## **PLANNING BOARD MEETING AGENDA**

Re: 33 Astor Place  
Monsey, NY, 10952  
Tax Lots: 41.06-1-78

**Re:** Nancy Rubin, 33 Astor Place – Clearing, Filling or Excavation Permit  
 SBL# 41.06-1-78

Attn: Alicia Schultz, Deputy Village Clerk  
Re: 33 Astor Place  
Clearing/Filling/Excavation Application Review

S.B.L. 41.06-1-78  
**PLOT PLAN**  
FOR  
**33 ASTOR PLACE**  
VILLAGE OF WESLEY HILLS - ROCKLAND COUNTY - NEW YORK

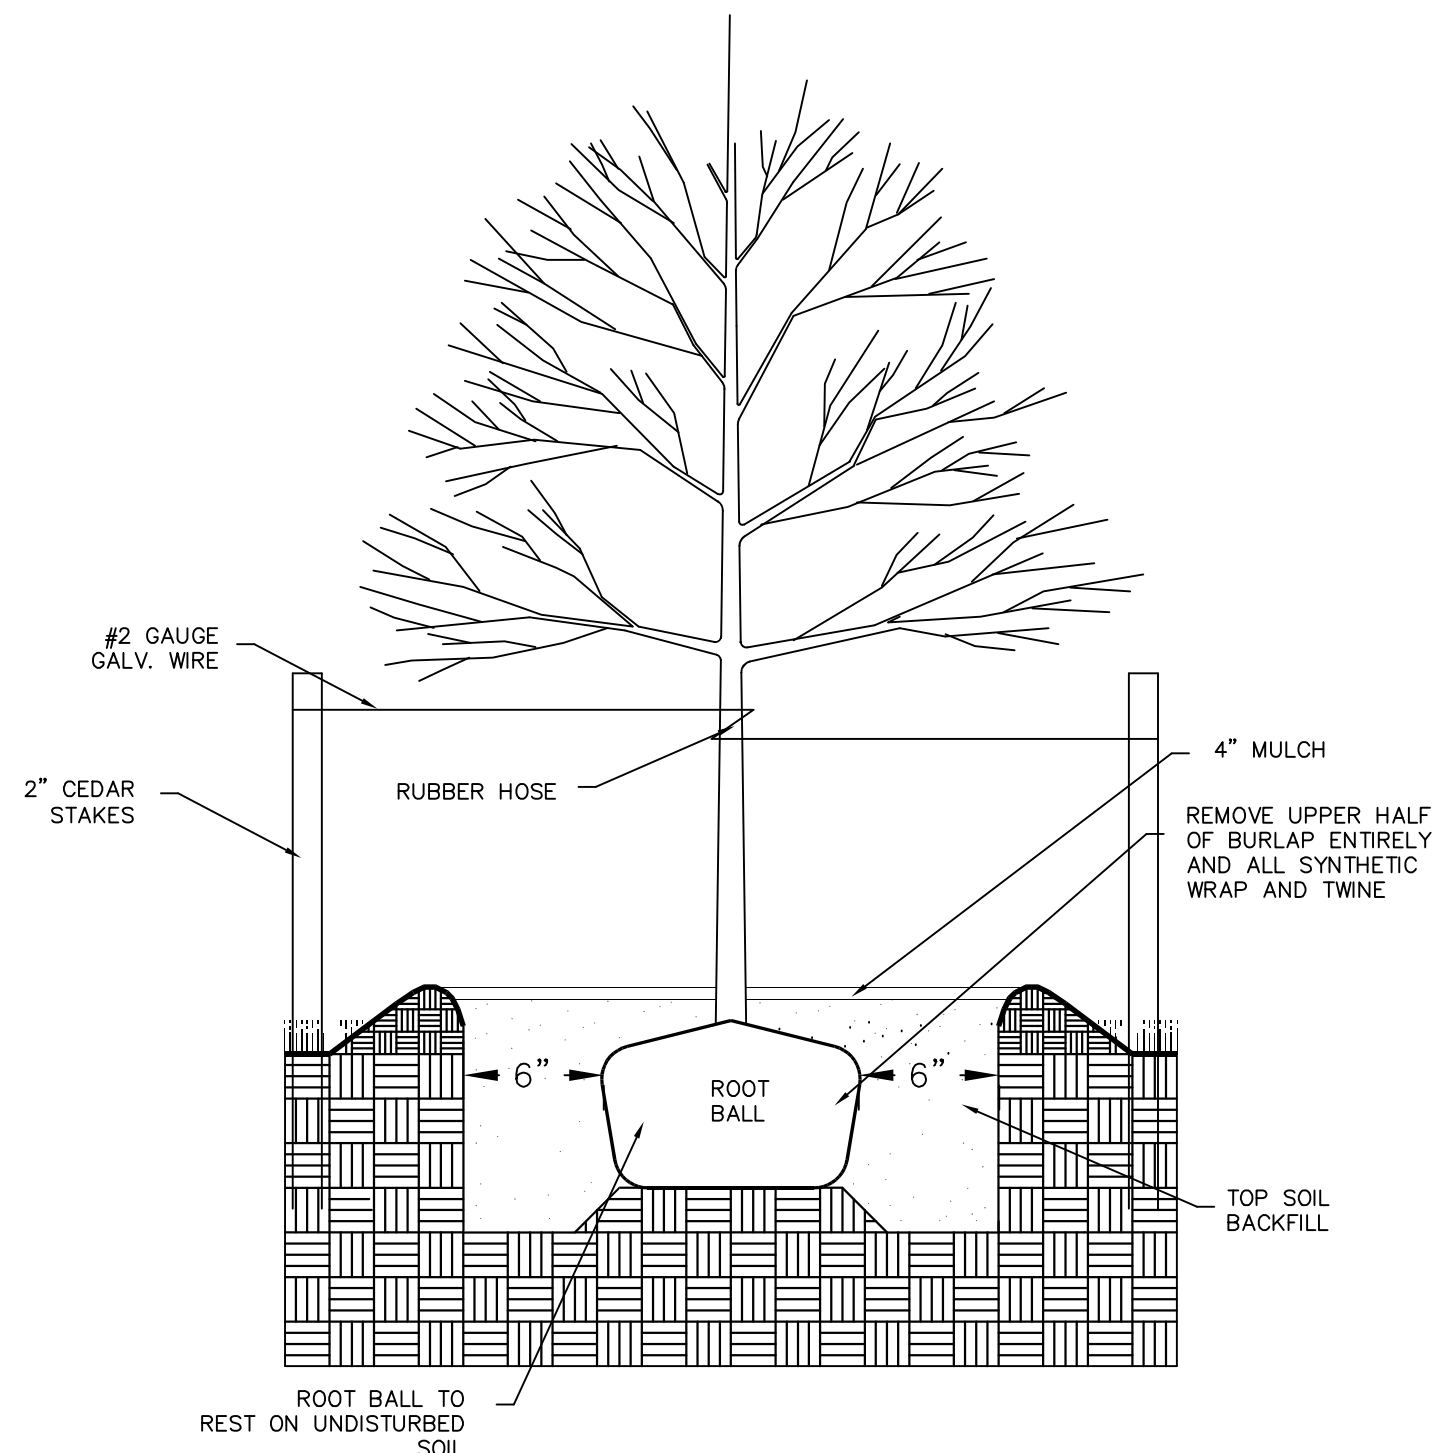
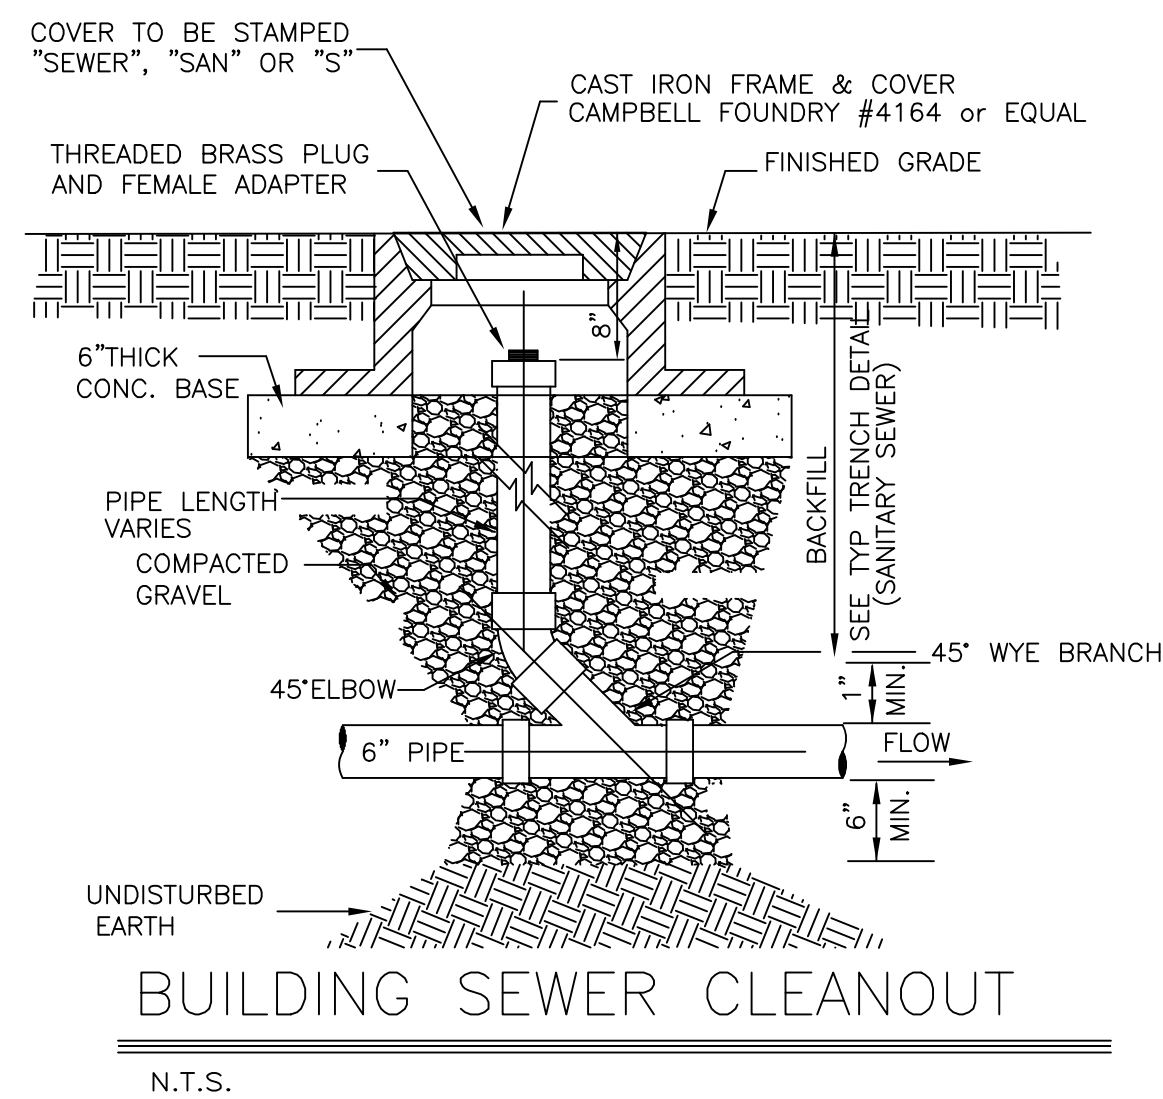
4. A standard detail for a Cambridge Sigma 8 wall has been provided. The detail does not indicate the proposed fence on top of the retaining wall as shown on the Civil Tec Plan. The discrepancy shall be resolved.
5. Pervious pavers are proposed in the rear yard; however, the previous response letter discussed high bedrock in the rear yard. Infiltration in fill is permitted, subject to minimum separation and testing requirements. Consideration as pervious area is not recommended if minimum requirements are not met. Applicant has responded that 'the pavers will all be fill so there will be

no separation issues with groundwater' This does not address insitu bedrock separation or insitu soil testing. We request the following criteria be provided as per NYS DEC guidance to be considered pervious:

- a. Insitu/natural soil layer below infiltration system has an infiltration rate greater than or equal to the 0.5 in/hr
- b. Ground water and bedrock levels in insitu/natural soil should be two to three feet below grade

- c. Fill material is an engineered fill that is tested after placement (by geotechnical firm) and demonstrated to be equivalent to a soil material acceptable for the installation of an infiltration system (i.e. infiltration rate greater than or equal to 0.5 inches /hr, etc.). Infiltration rate of fill material should be similar infiltration rate as insitu/existing soil.

- d. If there is a difference in the infiltration rates between the fill and insitu/native soil, the designer should use the more conservative (i.e. slower infiltration rate) when determining whether the infiltration system will dewater (exfiltrate) within the required 48 hours (see Section 6.3.2 "Conveyance" of the Design Manual).

- e. Required vertical separation distances to groundwater/bedrock are maintained
- f. Required horizontal separation distances to surface waters, wells, etc. are maintained

- g. There is adequate fill along the edges of the infiltration system to prevent seeps/breakouts
- h. As per guidance from the new draft NYS DEC Stormwater Management Design Manual, infiltration facilities proposed on naturally steep slopes require additional analysis. A slope stability / global stability analysis of the retaining wall shall be provided from a structural or geotechnical engineer.

**This remains to be addressed – soil test results to be submitted**

4. The structural engineer has now provided specific wall details. The fence has been moved 1' behind the wall.
5. The area with pavers will all be on fill so there will be no separation issues with groundwater or bedrock. The fill will be anywhere from 4' to 14' above existing grade. A note has been added that the fill under the pervious pavers must be at least 1" per hour to meet the design specifications. A percolation test done in the front yard in 2022 found bedrock at 5' with no signs of bedrock and a second location had no signs of bedrock or groundwater to a depth of 9'. I have attached the test results from 2022 now for reference.

**FINAL SURVEY FOR  
 91 SPOOCK  
 ROCK RD**

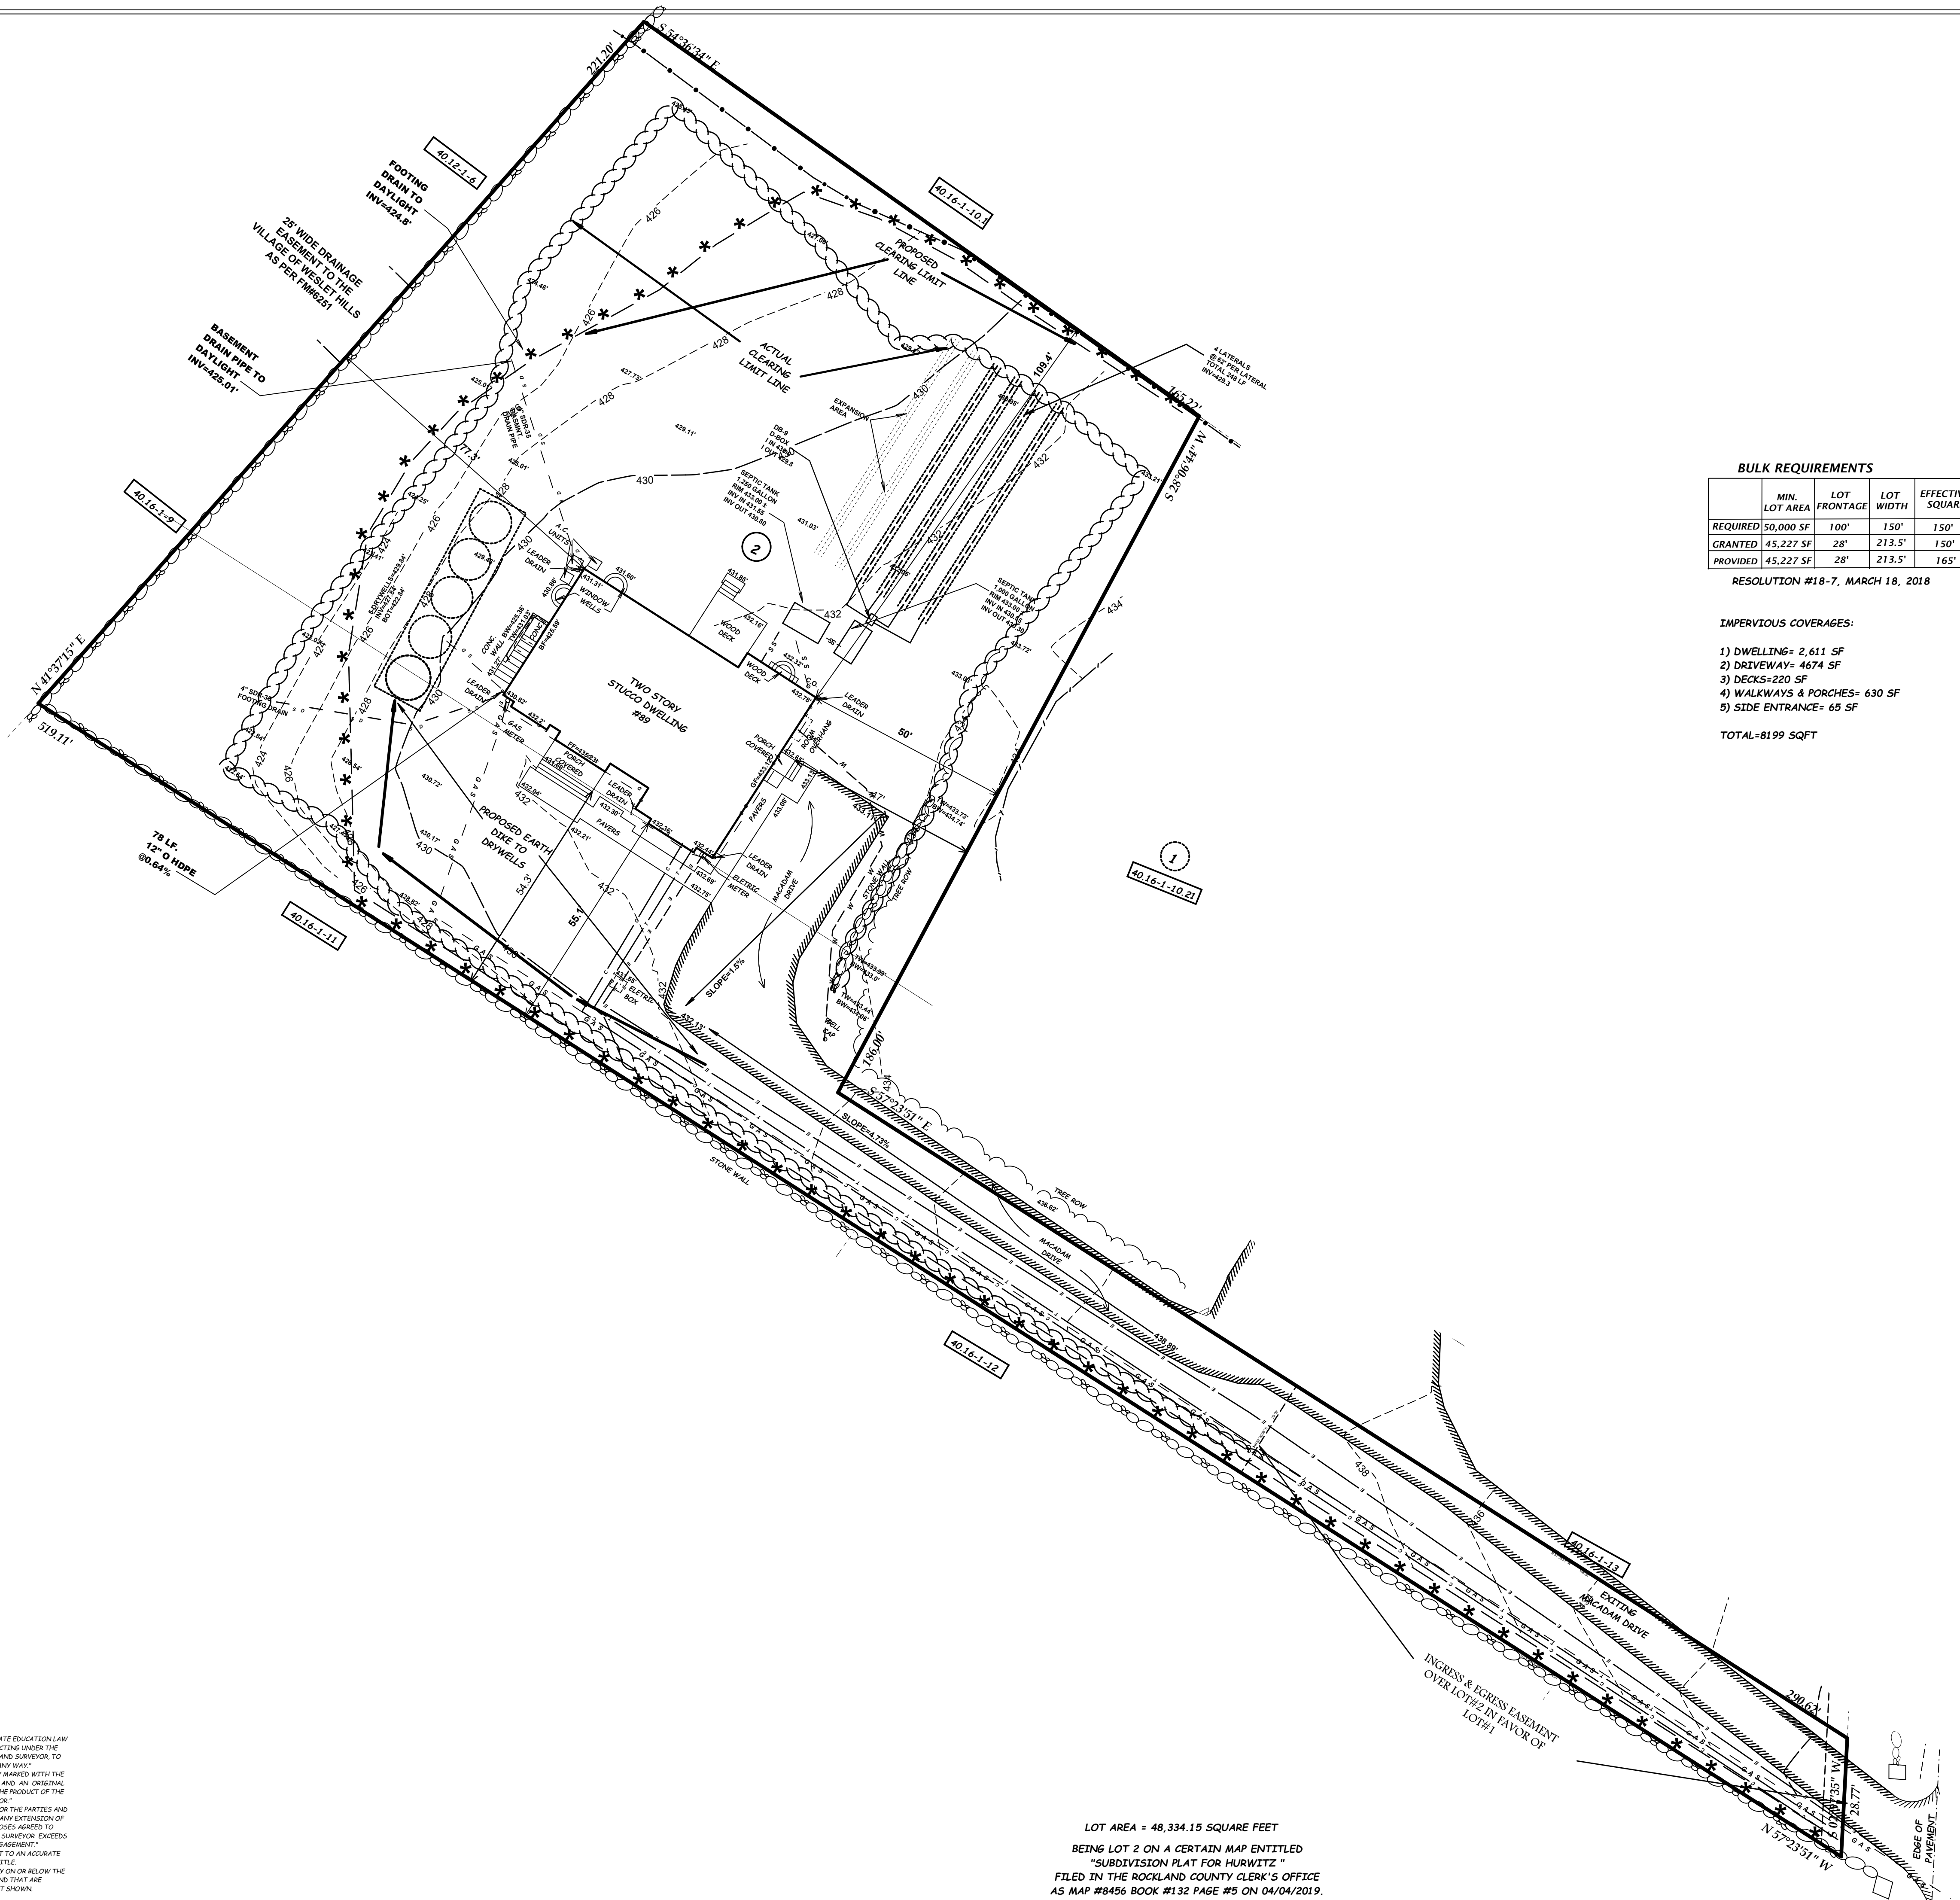
1. Front yard, side yard, and rear yard to be designated as they were in the approved Plot Plan. As-built survey to designate the same yards as approved. Front yard, side yard, and total side yard to be reviewed and corrected in the Bulk Table. The covered porch on the eastern face of the dwelling appears to encroach into the front yard setback. The Applicant has indicated that the cover over this porch can be easily removed. If the Applicant chooses to keep the covered porch, this non-conformance requires a variance and is referred to the Zoning Board of Appeals for further consideration.

2. Our approximate calculations indicate a greater area for the macadam driveway within the front yard. Front yard impervious ratio and maximum impervious surface calculations to be revised/confirmed to include the macadam driveway/front yard area as it was for the approved Plot Plans. A variance may now be required.

3. The macadam drive shown on the survey appears to encroach the property to the north, Tax Lot #40.16-1-10.21. Approved subdivision plans also included partial removal of pavement on Lot#1. It is noted that a letter from the neighboring property has been provided indicating that they agree to have a portion of the driveway for the subject property remain on their property. However, the driveway has been constructed differently than that of which is shown on the approved "Subdivision Plat for Hurwitz". Our office believes that the driveway should be reconstructed as it was proposed, or the project return to the Planning Board to record any necessary easements for the driveway encroachment. Our office defers to the Village Attorney regarding the appropriate course of action.

4. As requested in our final approval letter dated November 22<sup>nd</sup>, 2021:
  - a. All the plantings shown on the Planting and Erosion Control Plan from the approved planting plan for "Subdivision Plat for Hurwitz" shall be installed. Our site visit noted insufficient landscaping in regards to quantity, species, and sizes.

It appears that there has been disturbance beyond the approved clearing limit line near the northwest corner of the property. It appears that approximately twelve (12) trees that were proposed to remain appear to have been removed. The Applicant has indicated that the trees removed were dead prior to construction and other trees on the property (originally proposed to be removed) were protected due to field changes. Our office recommends an as-built tree survey be provided once the final landscaping and planting are implemented to determine if sufficient screening is provided to neighboring properties. A reappearance before the Planning Board may be necessary for revised plans and consideration for additional landscaping. Our office defers to the Village regarding the appropriate course of action.
